POWER PLANT - ENGINE - RESET EDUCTOR SYSTEM WITH REVISED HARNESS AND CLIPPING -
CATEGORY CODE 6 - MOD.ENG-71-0150

This Service Bulletin introduces a revised eductor system with improved operation capabilities and reliability.

V2500-ENG-71-0150

Oil scavenge tube (see Figure 7 for location) - Before and after alteration
Fig.31

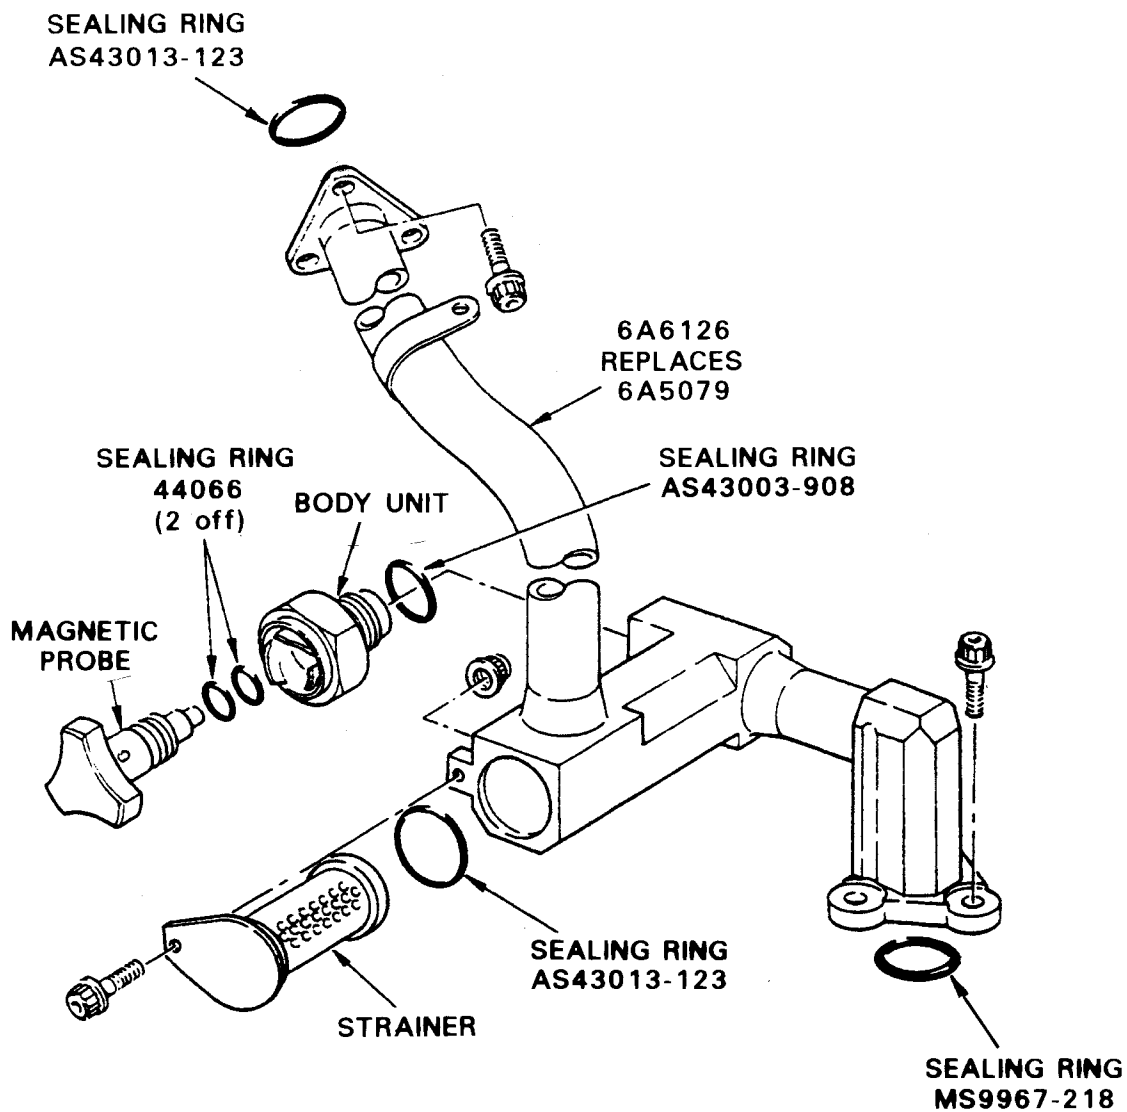
The new pipe assembly is identical to the existing except for the deletion of the J-blade for clipping point 2440 which has been deleted and an additional J-blade for new clipping point 2650 for support.

- (19) Reconnect the Loom 'A' and Loom 'B' electrical harness connectors to the FMU. Refer to Figures 1 and 2.
- (20) Lubricate a new AS43013-123 sealing ring with CoMat 10-077 approved engine oils. Install the sealing ring with the bolt, the strainer and the nut removed in step (12), on to the new 6A6126 oil tube. Torque the nut to 36 to 45 lbfin (4 to 5 Nm). Refer to Figure 31.

- (21) Lubricate two new 44066 sealing rings and a new AS43003-908 sealing ring with CoMat 10-077 approved engine oils. Install the sealing rings with the magnetic probe and the body unit removed in step (13), on to the new 6A6126 oil tube. Torque the body unit to 160 to 180 lbfin (18 to 20 Nm). Refer to Figure 31.
